ATLAS IRON WORKS ST. LOUIS, MO.	
Project:	WEBSTER ISB - MOCKUP A'
Customer:	PARIC CDRP
Owner:	WEBSTER UNIVERSITY
Location:	ST. LOUIS, MO
Dwn:	DC
Date:	6/16/16
Ckd:	
Date:	
Job No.	A16013-MU
BAT:	
DWG#:	MUA-E1

PROJECT: 15051-Webster University Interdisciplinary Science Building

RE: Structural Steel Mockup Shop Drawings
REV2

RE: Structural Steel Mockup Shop Drawings

PLAN VIEW

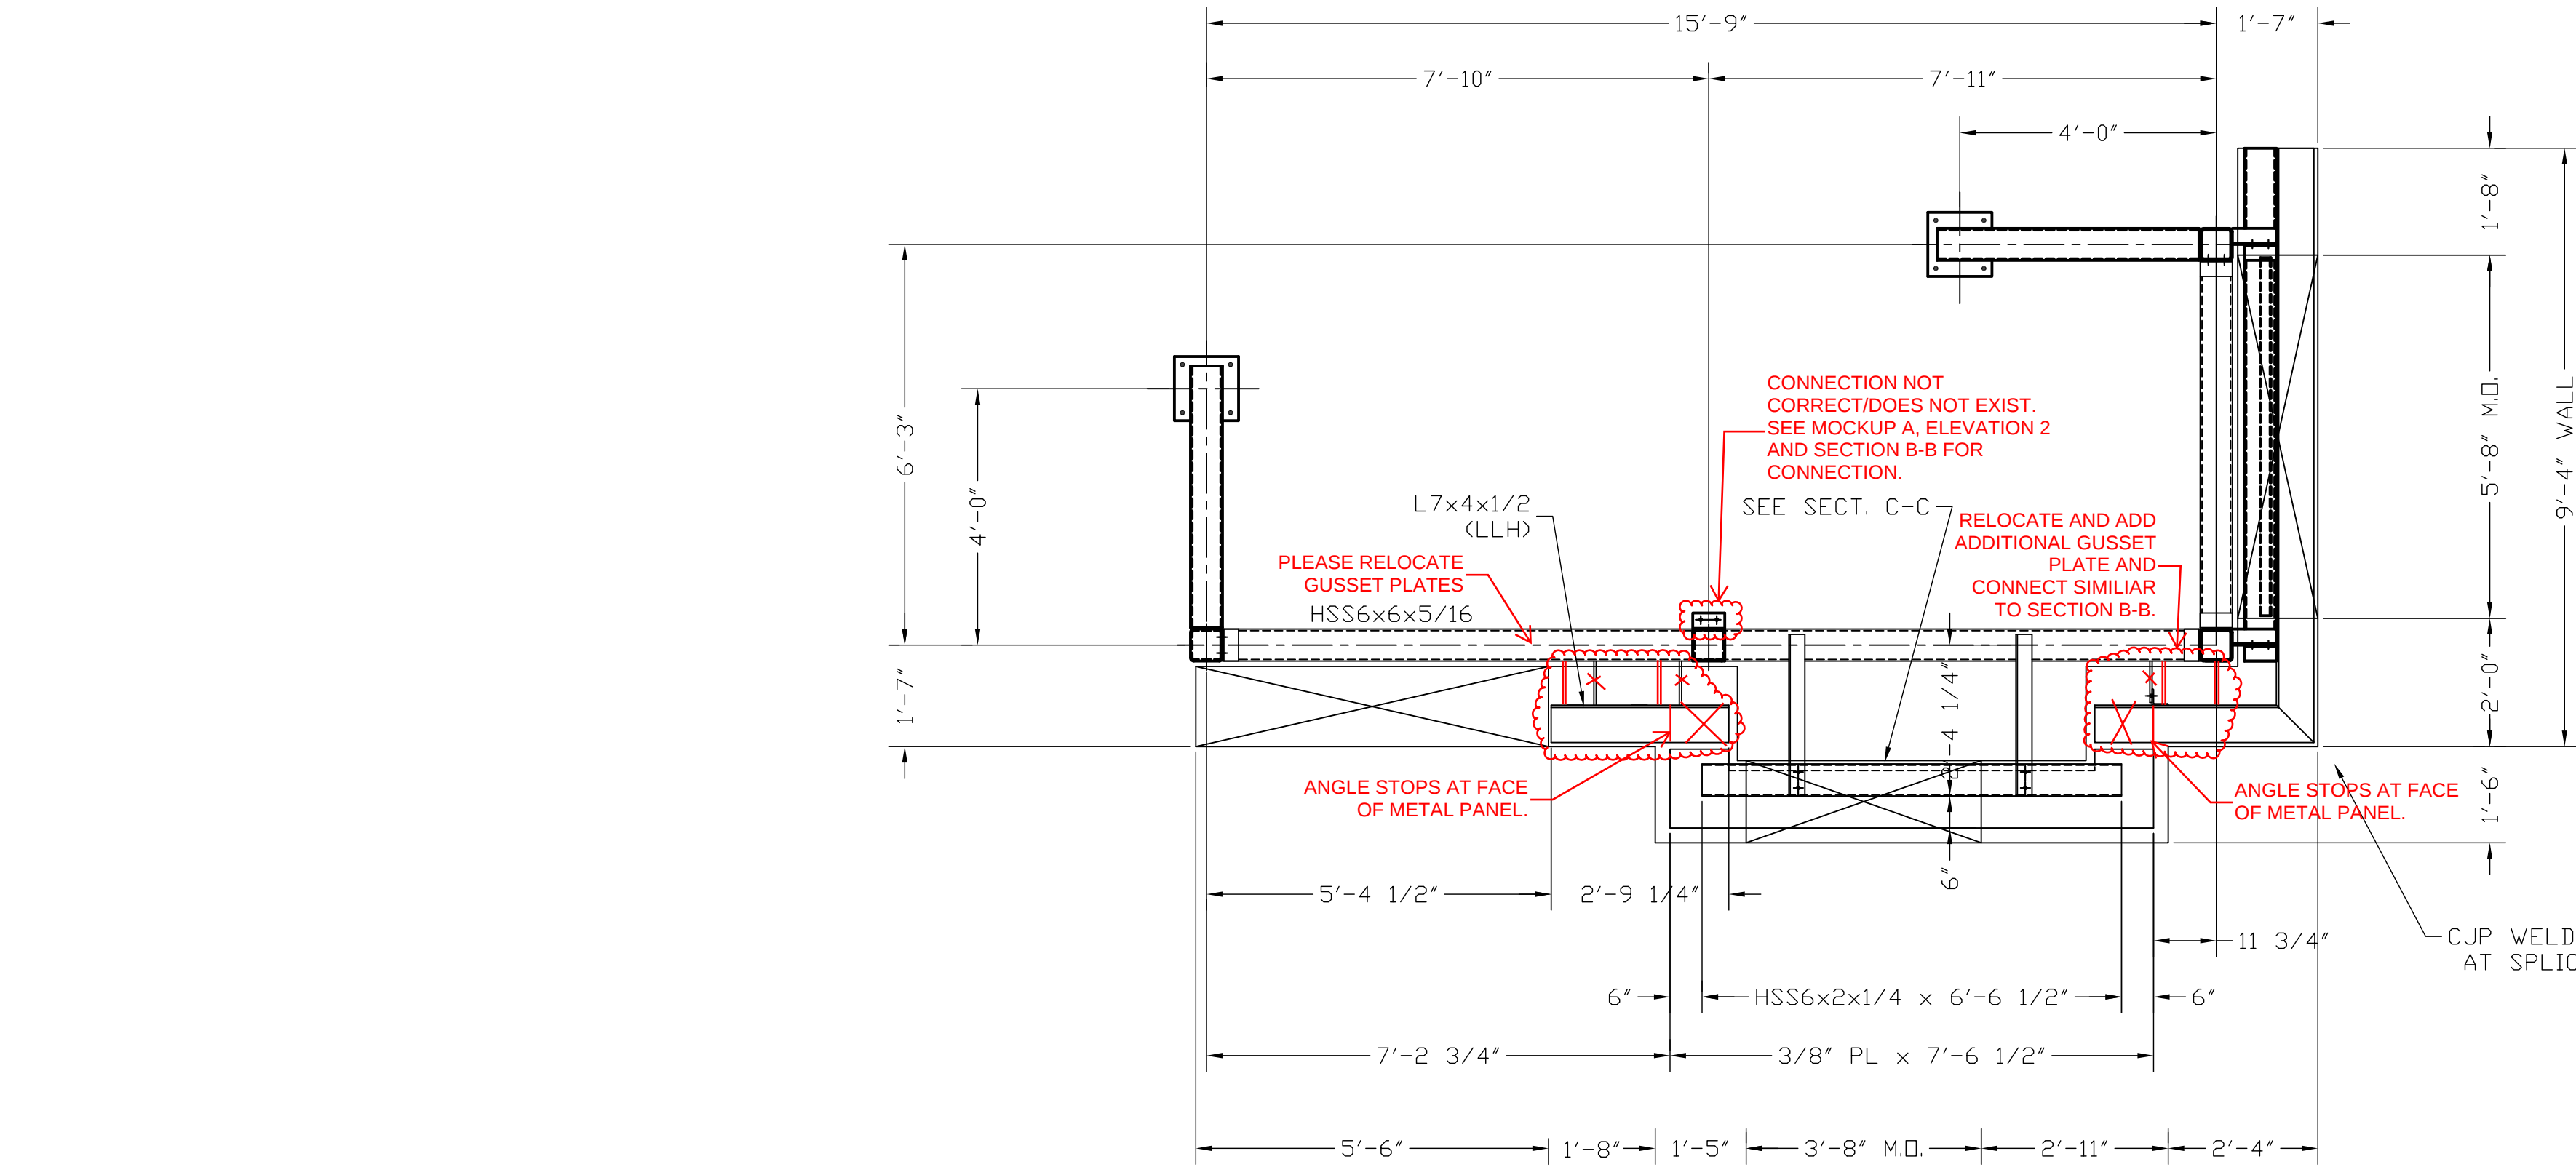
PROVIDE DETAILS OF ANCHOR BOLTS, INCLUDING SIZE, EMBEDMENT AND LAYOUT FOR TEMPLATE. TYPICAL. JYW/DMA

APPROVER NOTE:
THIS ENTIRE LAYOUT IS PREDICATED
ON THE CONCEPT THAT THE WALLS
AND FOUNDATIONS MATCH AT THIS
CORNER (PER 1/A0452)

SEE ANCHOR PLAN BELOW

MOCKUP A, ELEVATION 2 (2/A0490)

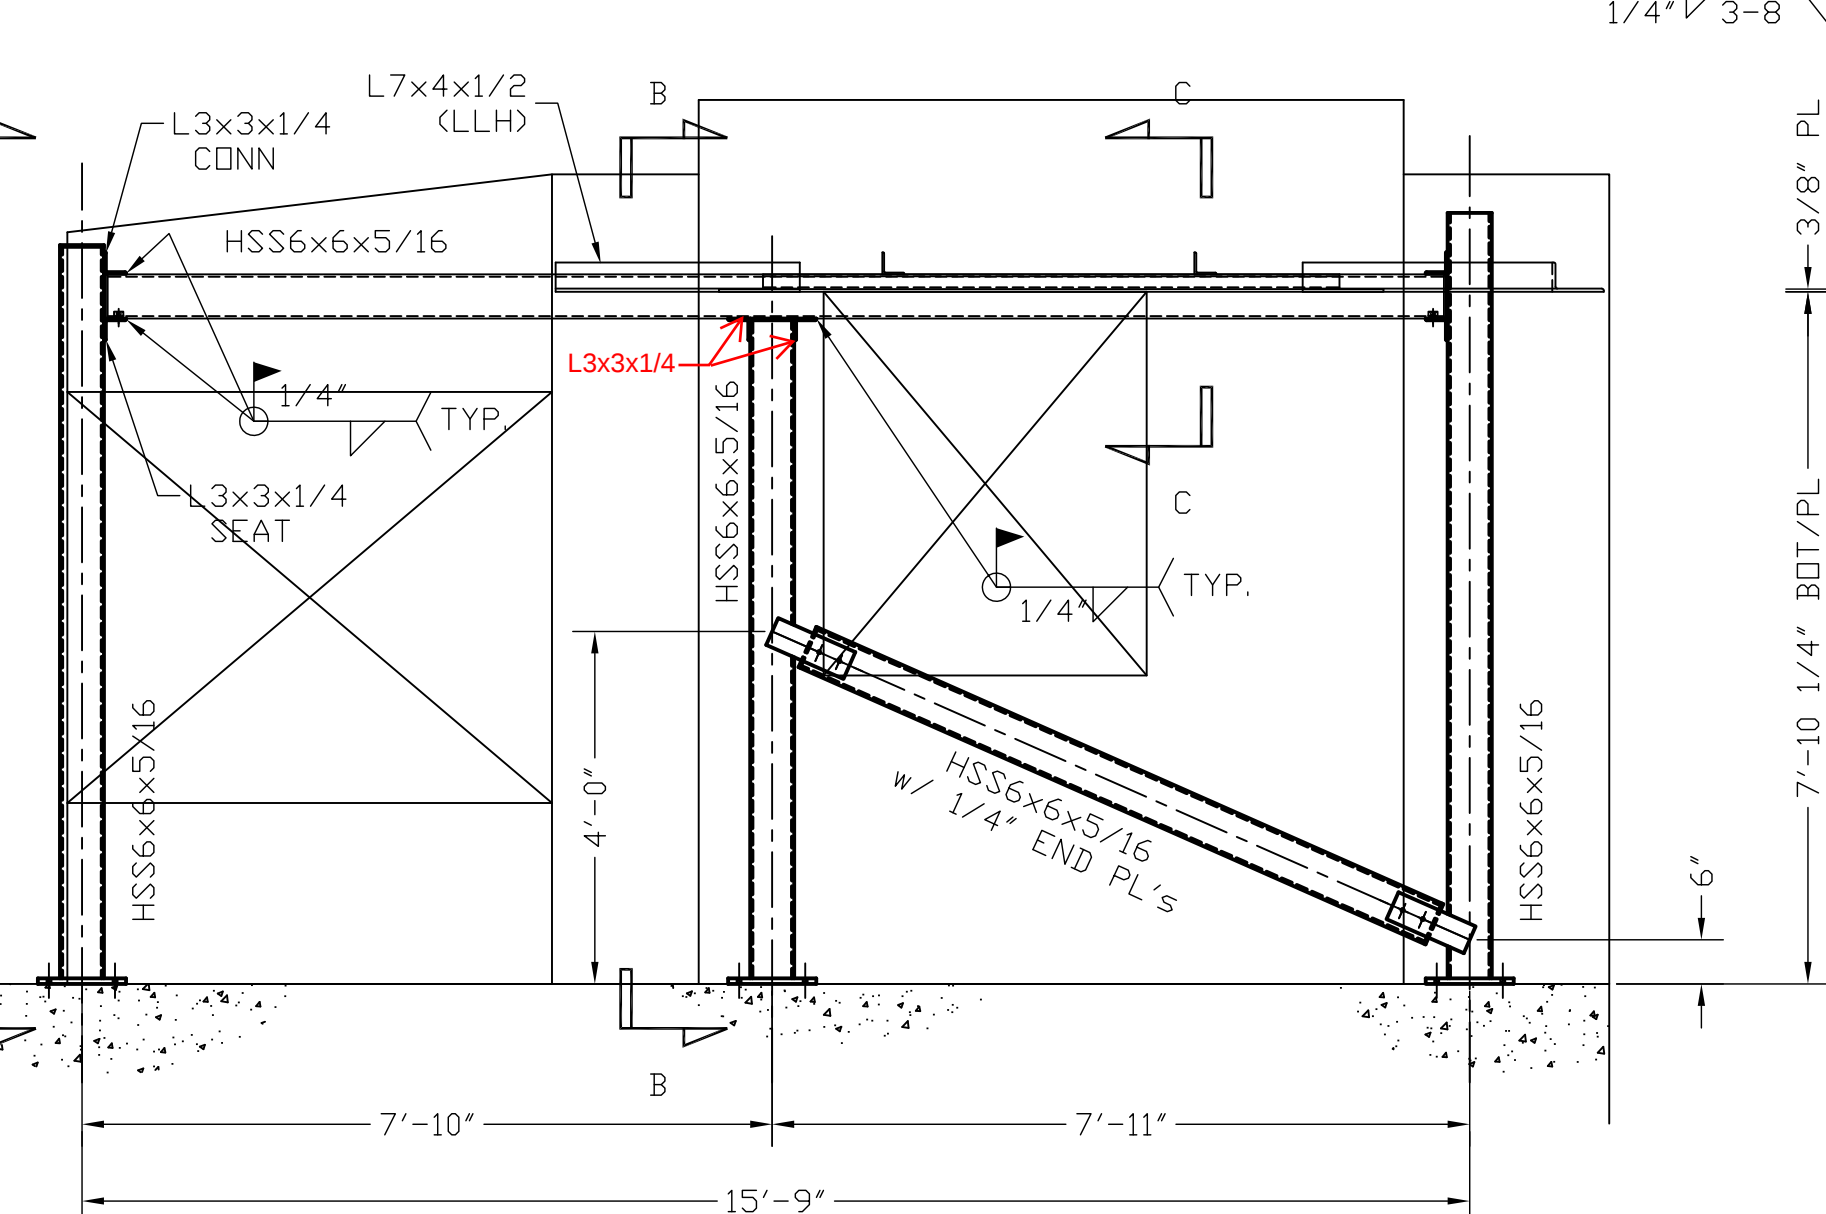
ATTACH VERTICAL
HSS6X5/16 TO HORIZONTAL
HSS6X5/16 WITH (2) L3X3/4
WITH 1/4" FILLET WELD
SIMILAR TO THE LEFT DETAIL

HSS6X5/16 CONNECT
TO EACH VERTICAL
TUBE SIMILAR TO
SECTION A-A.

SECTION C-C

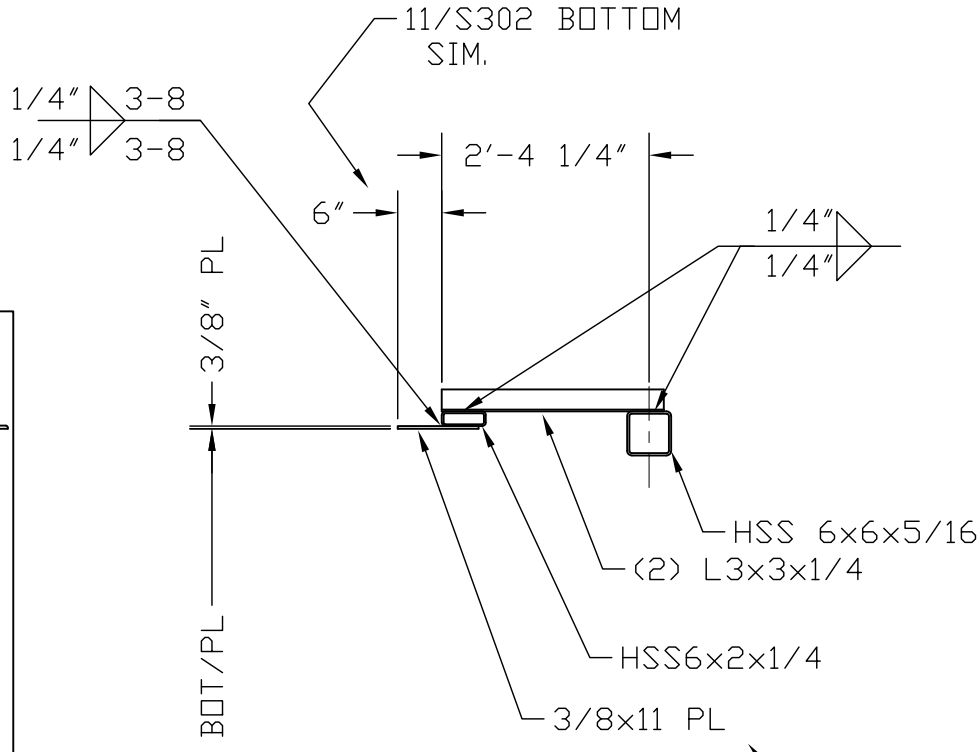
APPROVER!
~ PLEASE VERIFY 3/8" PL
SHELF L's ARE 1/2" D

CORRECT

MOCKUP A, ELEVATION 1 (3/A0490)

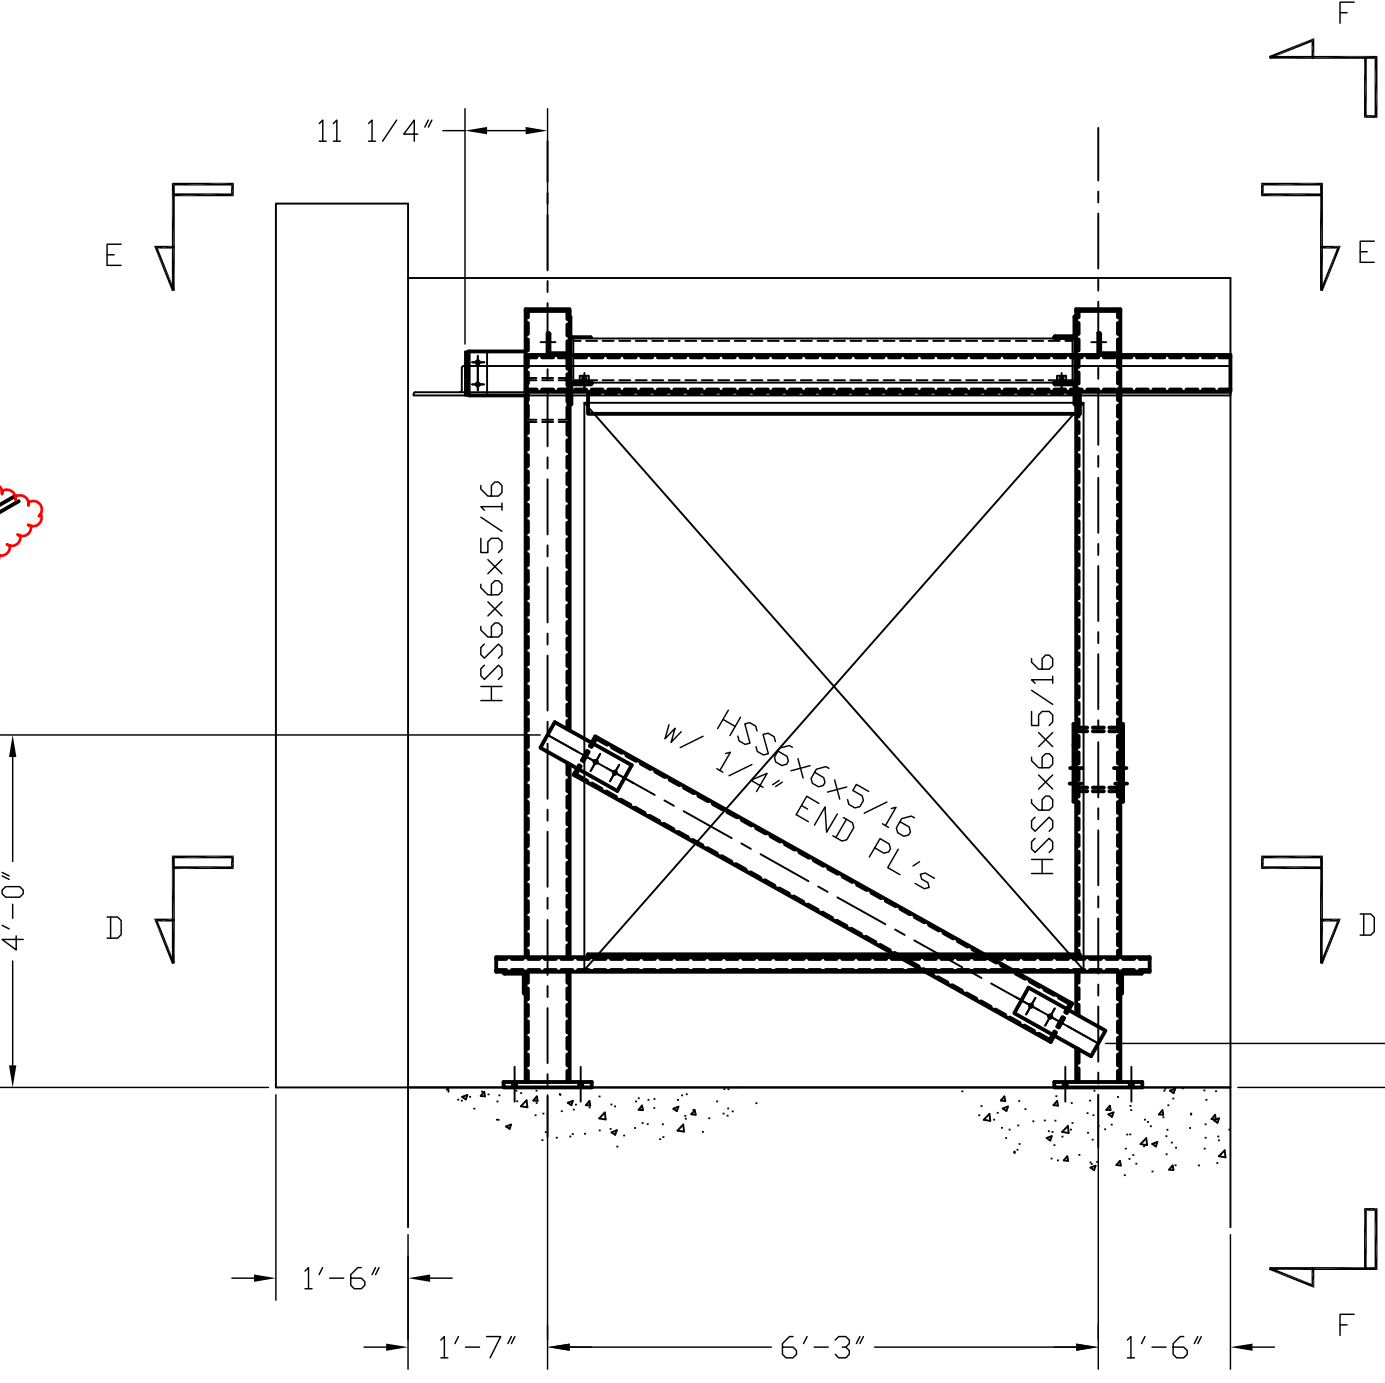
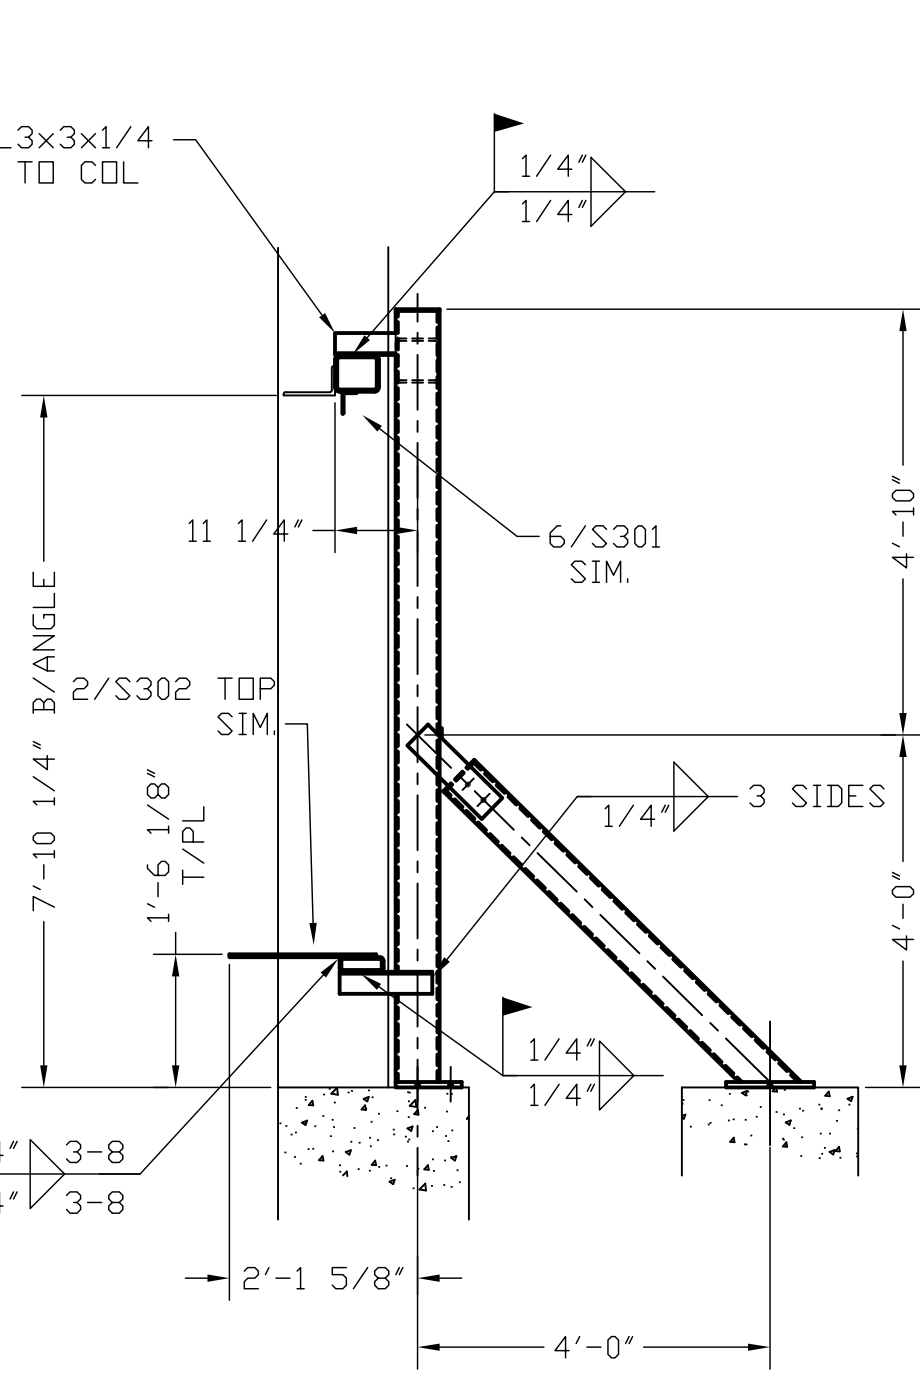
NOTE:
ADD 1/4" CAP PLATE TO ALL TUBES,
PROVIDE 1/4" WELD ALL AROUND AT
CAP PLATE
